**2019 SMP PACKAGE I
(AVENIDA PRIMA, LA AVENTURA, & LA BAHIA)
Solicitation Number: CO-00201
Job No.: 18-5008 and 18-5508**

**ADDENDUM NO. 1
August 14, 2018**

DEVELOPER: []
 CONT. [] BUDGET PROJ.
 SUBMITTED []
 APPROVED []
 MAP No. 188622 AND 190620 SHEET 14
 SECT. No. [] OF 29
 DR. [] CK. [] JOB No. 18-5008

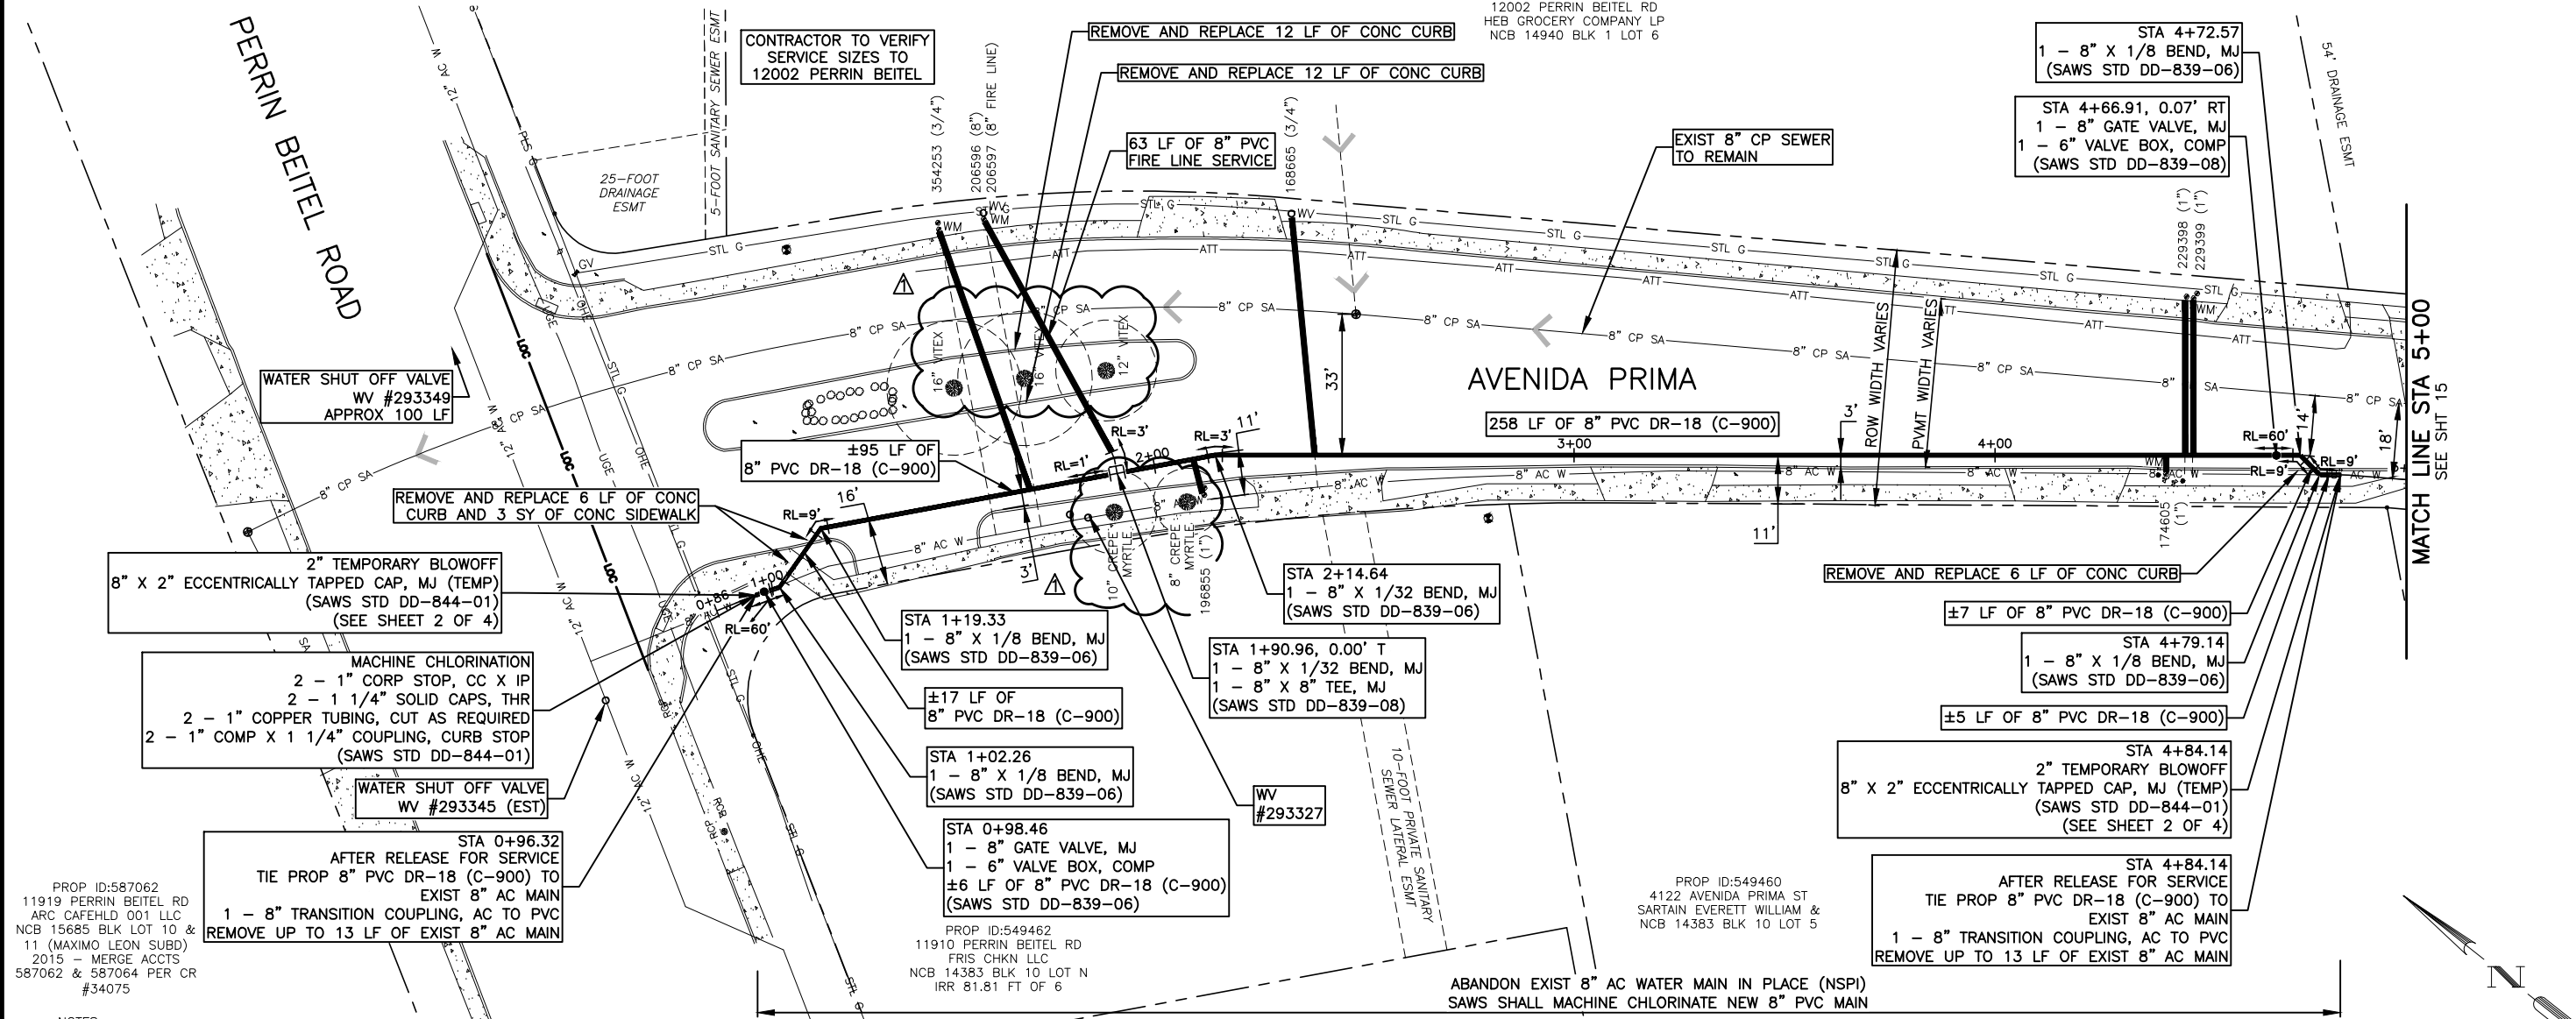
- 6. DELETE Sheet 14 of 29 of the WATER PLANS in its entirety and REPLACE with the attached Sheet 14 of 29, dated 7/27/18. Sheet 14 has been revised to show updated tree species and/or location.**

| MAP No. | 188622 AND 190620 | SHEET | 15 |

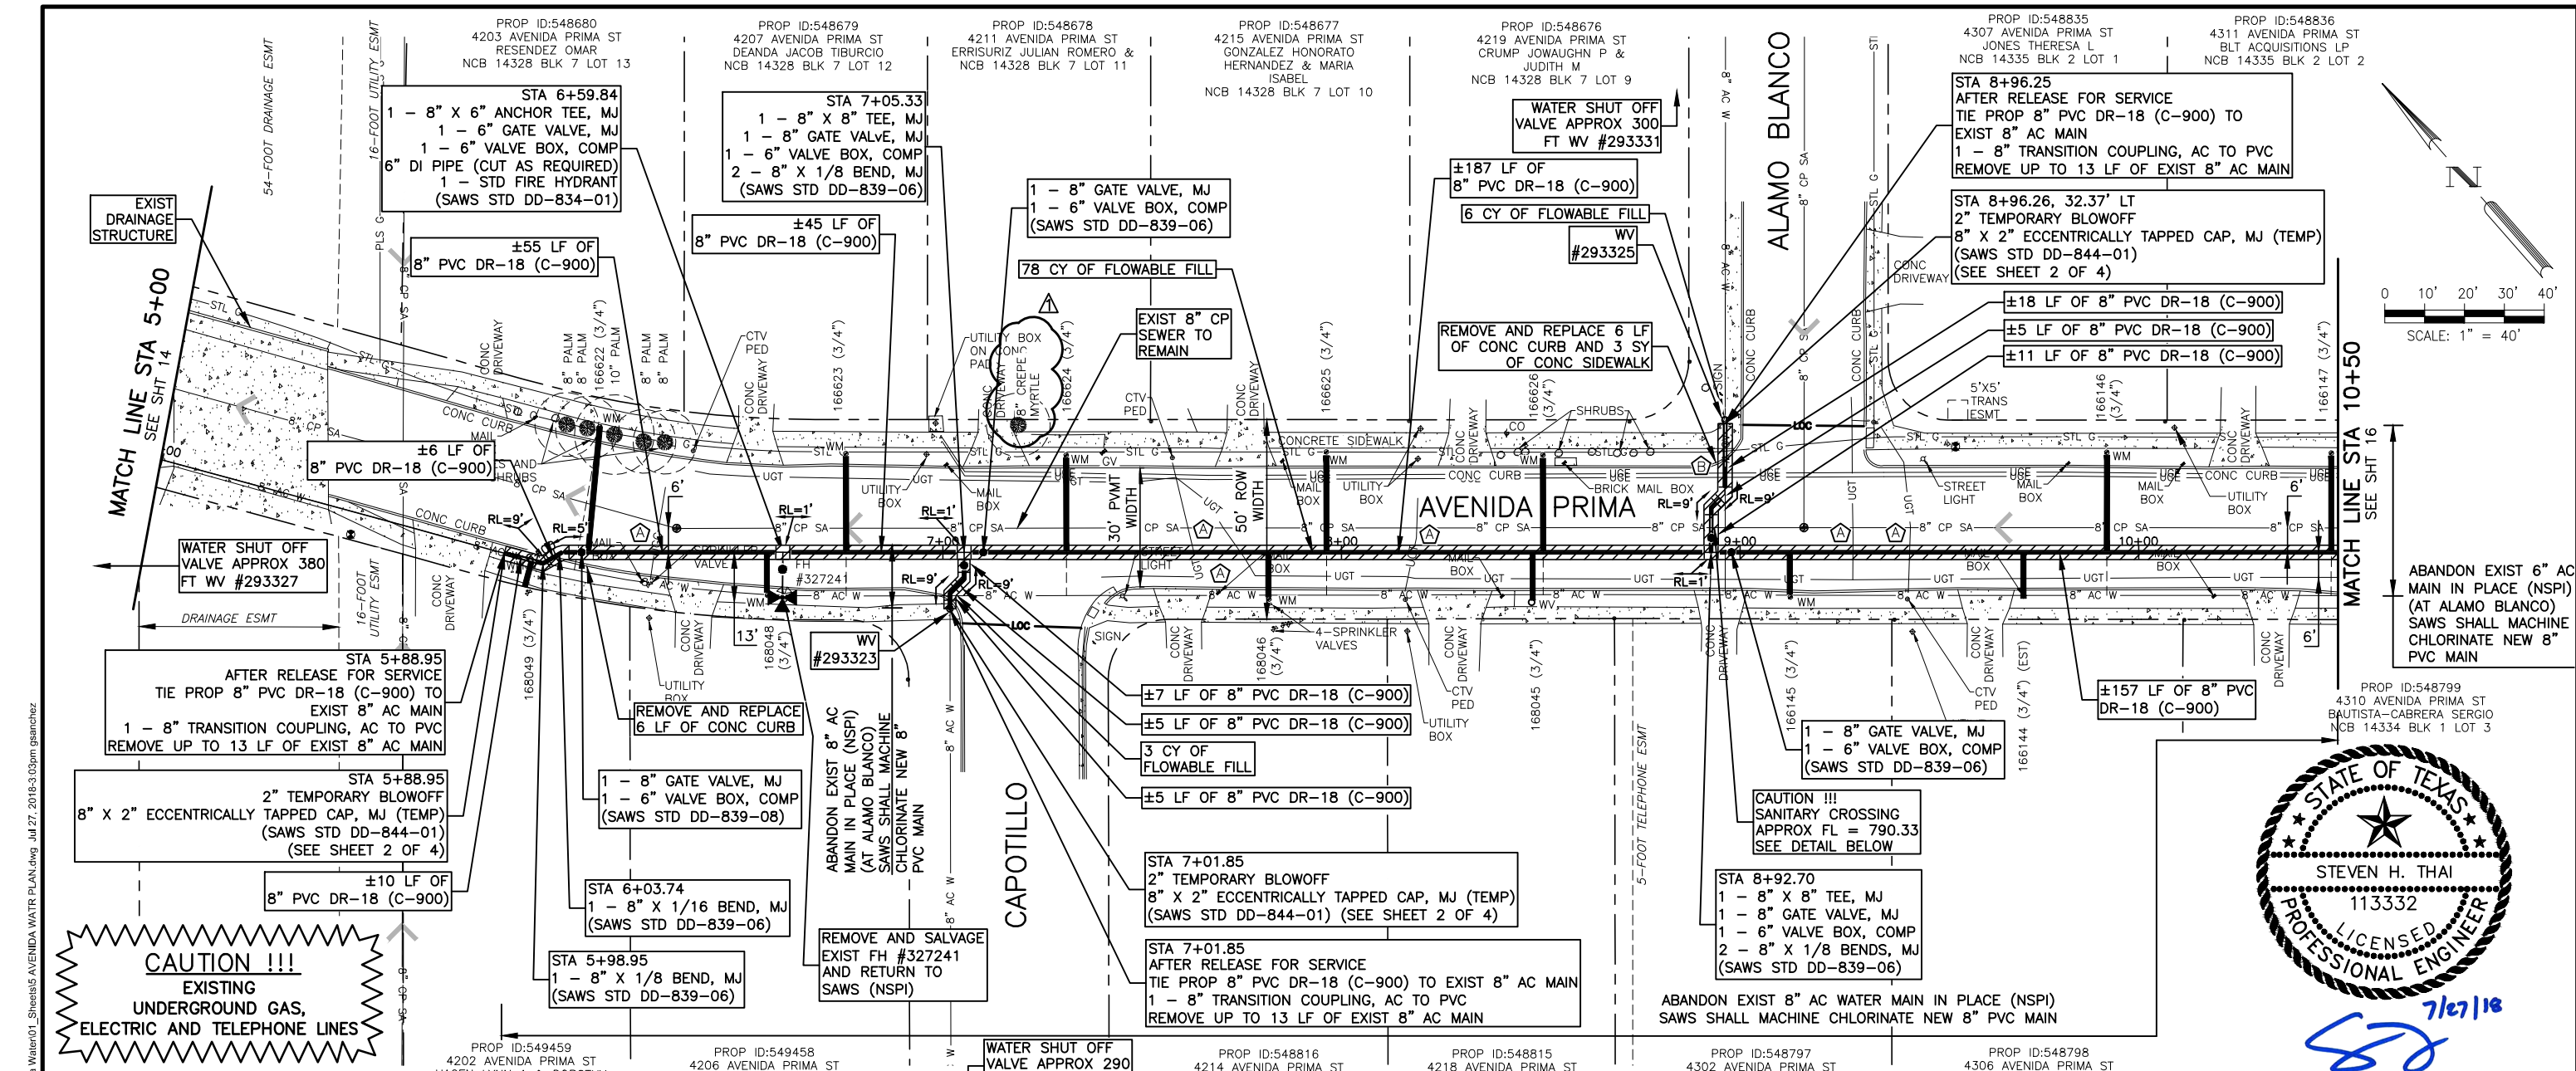
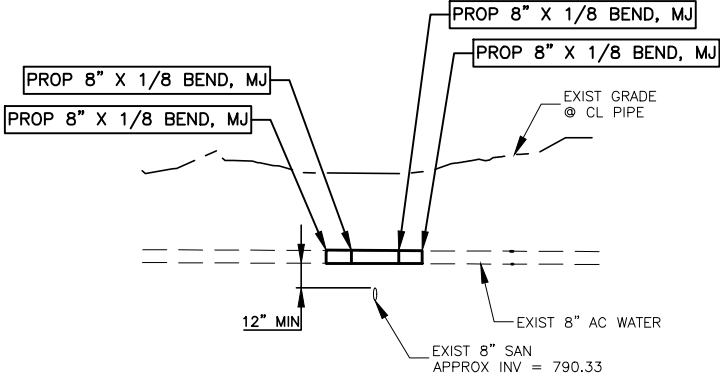
- 7. DELETE Sheet 15 of 29 of the WATER PLANS in its entirety and REPLACE with the attached Sheet 15 of 29, dated 7/27/18. Sheet 15 has been revised to show updated tree species and/or location.**

| MAP No. 188622 AND 190620 | SHEET 19 |

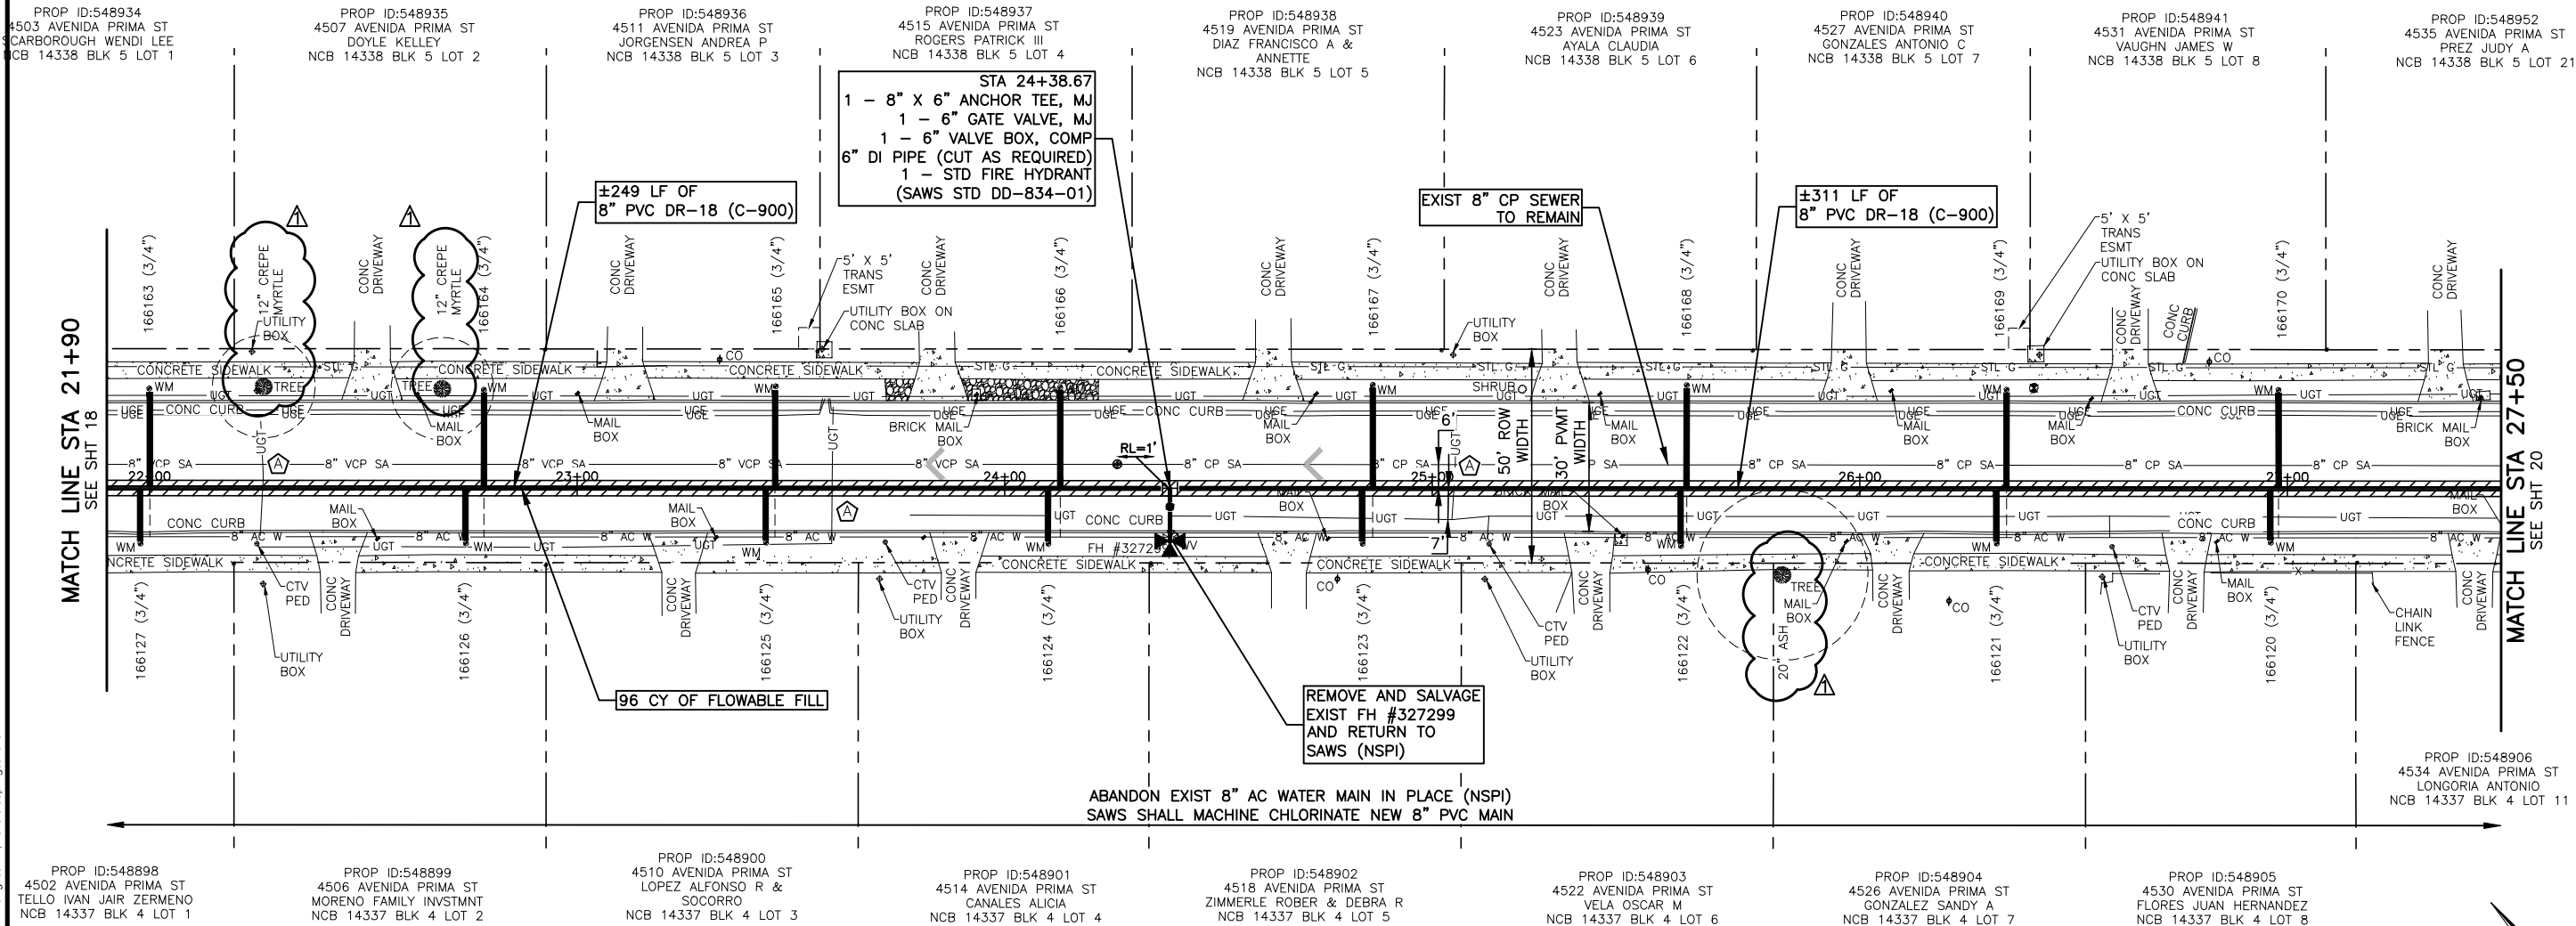
- 8. DELETE Sheet 19 of 29 of the WATER PLANS in its entirety and REPLACE with the attached Sheet 19 of 29, dated 7/27/18. Sheet 19 has been revised to show updated tree species and/or location.**
